The Commission has issued the enclosed Amendment No. 33 to Facility Operating License No. DPR-28 for the Vermont Yankee Nuclear Power Station. The amendment consists of changes to the Technical Specifications in response to your application dated November 9, 1976.

This amendment revises the pressure-temperature limitations in order to comply with 10 CFR Part 50, Appendix G, "Fracture Toughness Requirements." It also establishes a surveillance capsule removal schedule to assure compliance with 10 CFR Part 50, Appendix H, "Reactor Vessel Material Surveillance Program Requirements."

Amendment No. 33
License No. DPR-28

ATTACHMENT TO LICENSE AMENDMENT NO. 33

FIGURE 3.6.1
 REACTOR VESSEL PRESSURE
 TEMPERATURE LIMITATIONS
 for operation through 8.0×10^7 MWH(t)
 RT_{NDT} @ 1/4t = +70°F @ 3/4t = +65°F

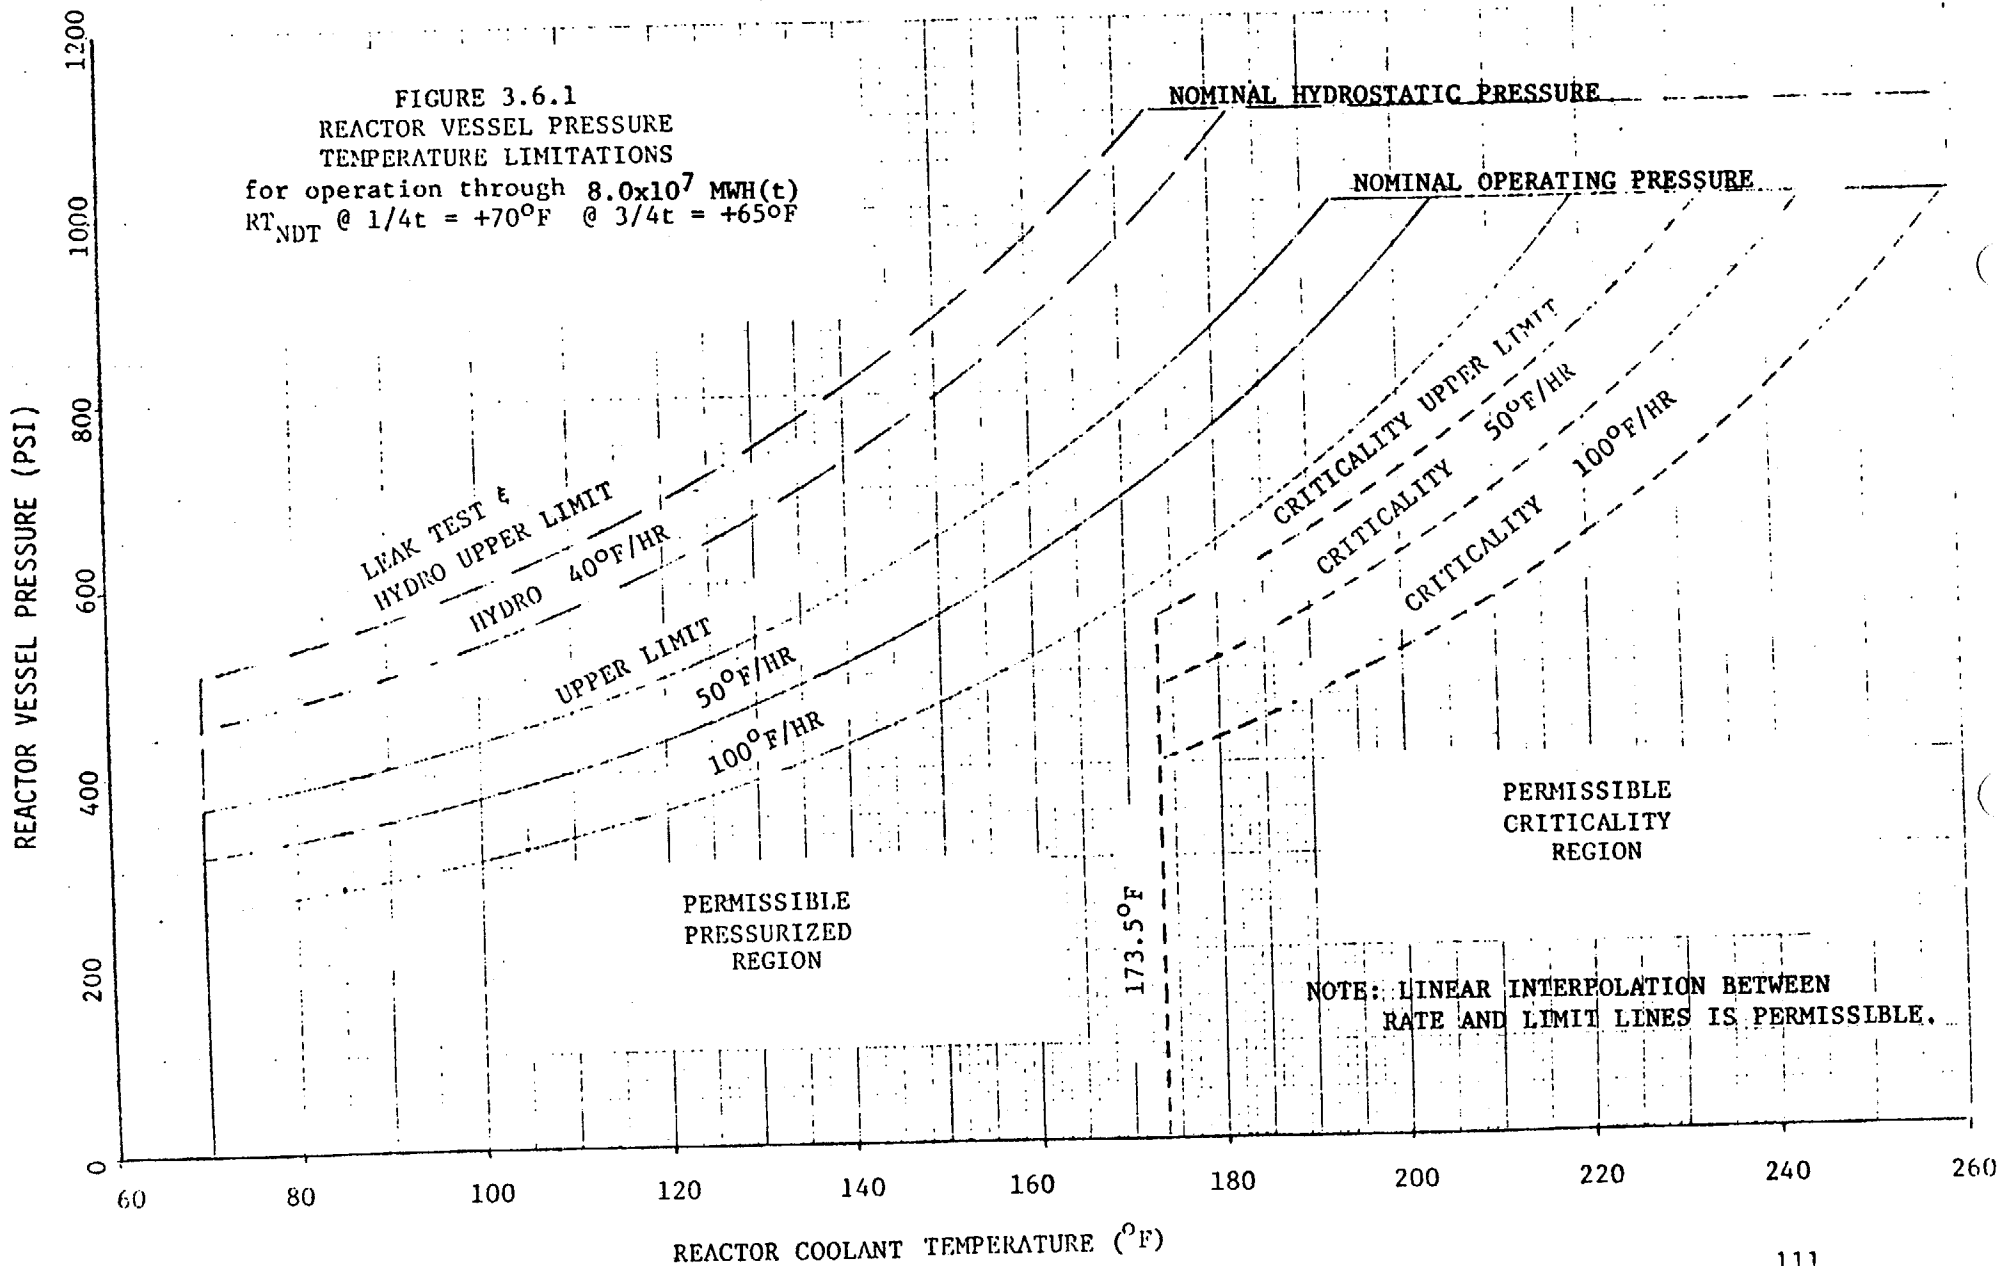
1. The reactor coolant system temperature and pressure shall be limited in accordance with the limit lines shown on Figure 3.6.1 during heatup, cooldown, criticality (except for the purposes of low power physics testing), and in-service leak and hydrostatic testing.
2. The maximum heatup or cooldown rate is 100°F when averaged over any one hour period.
3. The reactor vessel head bolting shall not be tensioned unless the temperature of the vessel head flange and the head is greater than 70°F.
4. The pump in an idle recirculation loop shall not be started unless the temperatures of the coolant within the idle and operating recirculation loops are within 50°F of each other.

The pressure-temperature limit lines shown on Figure 3.6.1 for reactor criticality and for inservice leak and hydrostatic testing have been provided to assure compliance with the minimum temperature requirements of Appendix G to 10 CFR 50 for reactor criticality and for inservice leak and hydrostatic testing.

VYNPC proposed a revision to Technical Specification 3.6/4.6A, "Pressure and Temperature Limitations," for VYNPS. The proposed operating limits were calculated in accordance with Appendix G, 10 CFR Part 50, and Standard Review Plan 5.3.2 which includes Branch Technical Position MTEB 5-2. These new operating limits were based on a fluence at the vessel wall inside diameter of 2.9×10^{17} neutrons per square centimeter (n/cm^2) and calculated for operation through 1.3×10^8 megawatt hours thermal (MWH(t)), approximately 13 effective full power years (EFPY). At this point in time the limiting reference temperature (RT_{NDT}) of the vessel was calculated to be 70°F. We find that the calculations performed were in accordance with 10 CFR Part 50, Appendix G, and are therefore acceptable. The basis for the fluence estimation was an analysis performed by Southwest Research Institute on a vessel wall dosimeter removed from the vessel in October 1974. This analysis is presented in Southwest Research Institute Report SWRI Project 02-4032, May 23, 1975. We find that their estimate for fluence at the vessel wall at end of life may be low in view of higher values now estimated for similar facilities. On this basis, we have reduced the time period relating to the pressure-temperature limits proposed in Technical Specification 3.6/4.6A and Figure 3.6.1 from 1.3×10^8 MWH(t) to 8.0×10^7 MWH(t). We have discussed this change with VYNPC and they have agreed. Based on this change, we conclude that the resulting values and the calculational methodology employed are acceptable.

FIGURE 3.6.2

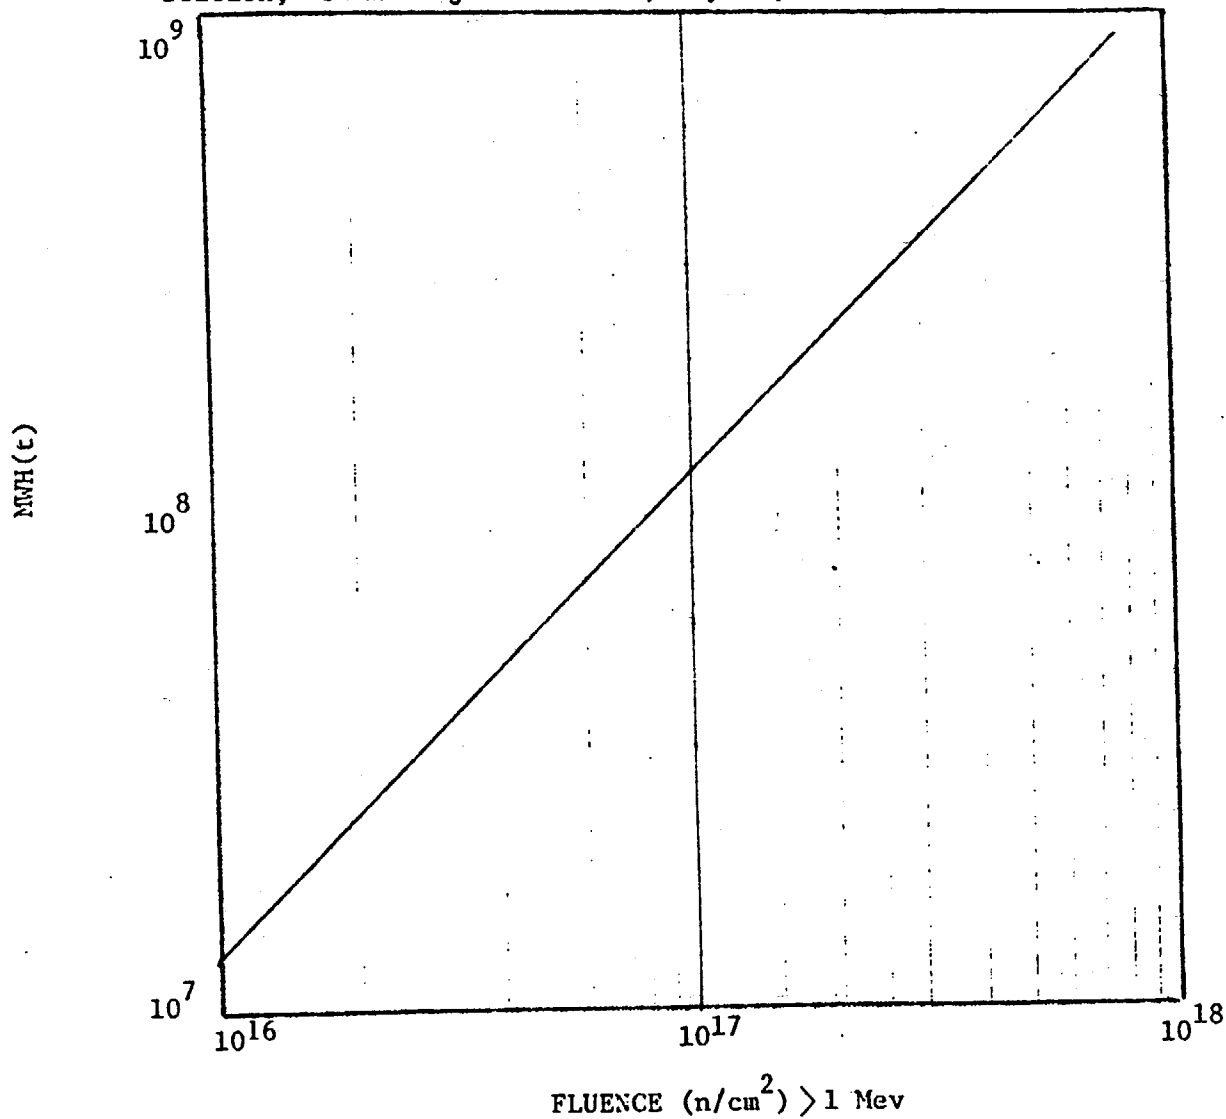
The results shall be used to update Figures 3.6.2 and 3.6.3. The removal times shall be referenced to the refueling outage following the year specified, referenced to the date of commercial operation.
